LINCOLN:

2017 Continental

Some 2017 Continental vehicles may exhibit a ratcheting type noise when using the floor console top forward media door.

Figure 1 - Article 17-0064

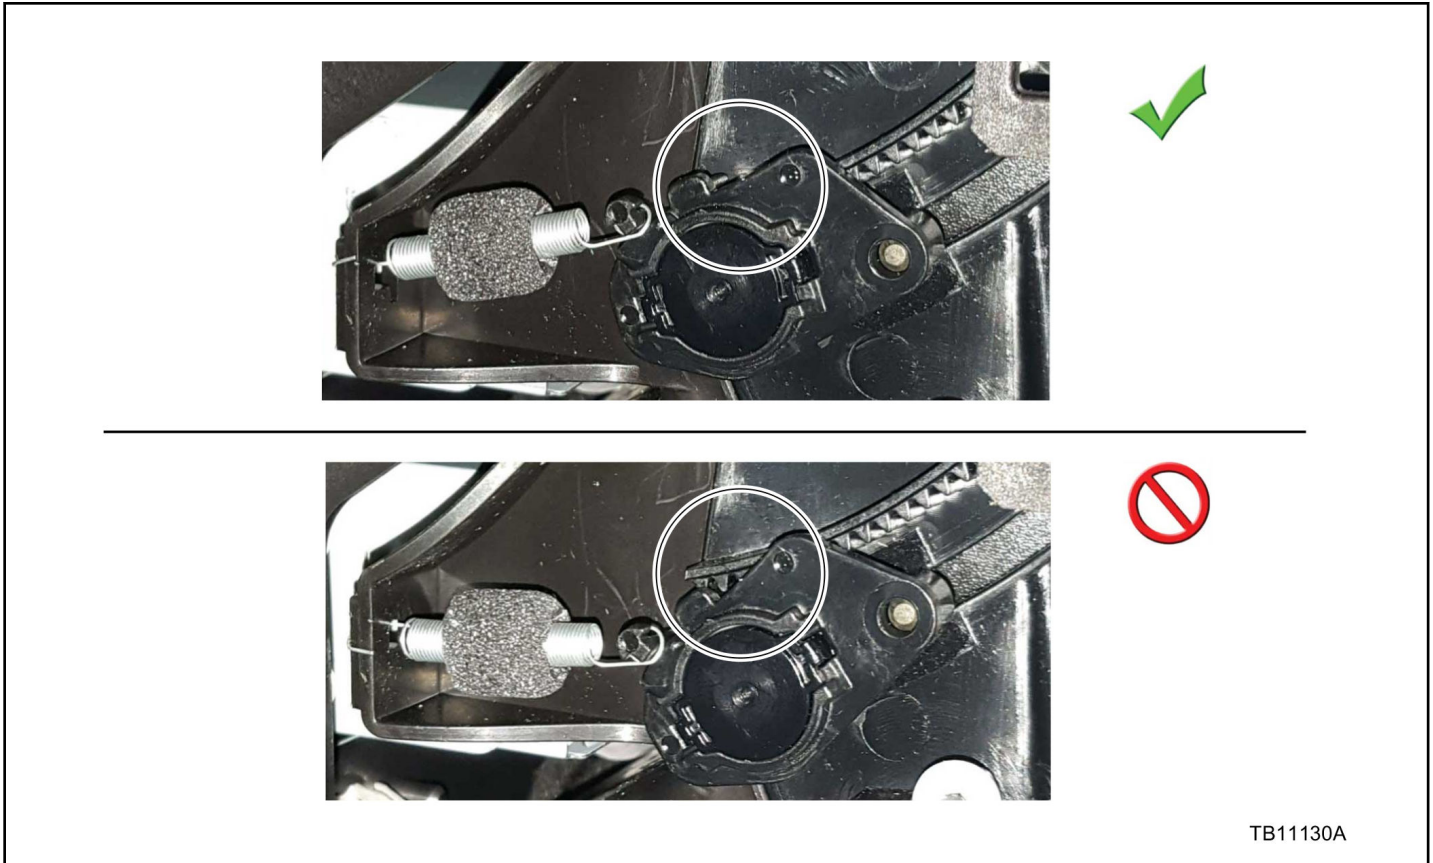
1. Does the floor console top forward media door exhibit a ratcheting type noise when it is being used?
 - a. Yes - proceed to Step 2.
 - b. No – this article does not apply. Refer to Workshop Manual (WSM), Section 501-12.
2. Access the rear of the floor console and remove the floor console rear trim panel. Refer to WSM, Section 501-12.
3. Position the left front seat to the full rearward position and move the seat back to the recline position.
4. Raise the floor console center armrest lid.
5. Release the left side floor console side trim panel clips and remove the panel. Refer to WSM, Section 501-12.
 - a. The wiring does not need to be disconnected.
6. Open the front media door to gain access to the spring attachment guide. Position the spring attachment guide over the top of the console teeth row. (Figure 1)

7. To reassemble, reverse the removal procedure. Refer to WSM, Section 501-12.
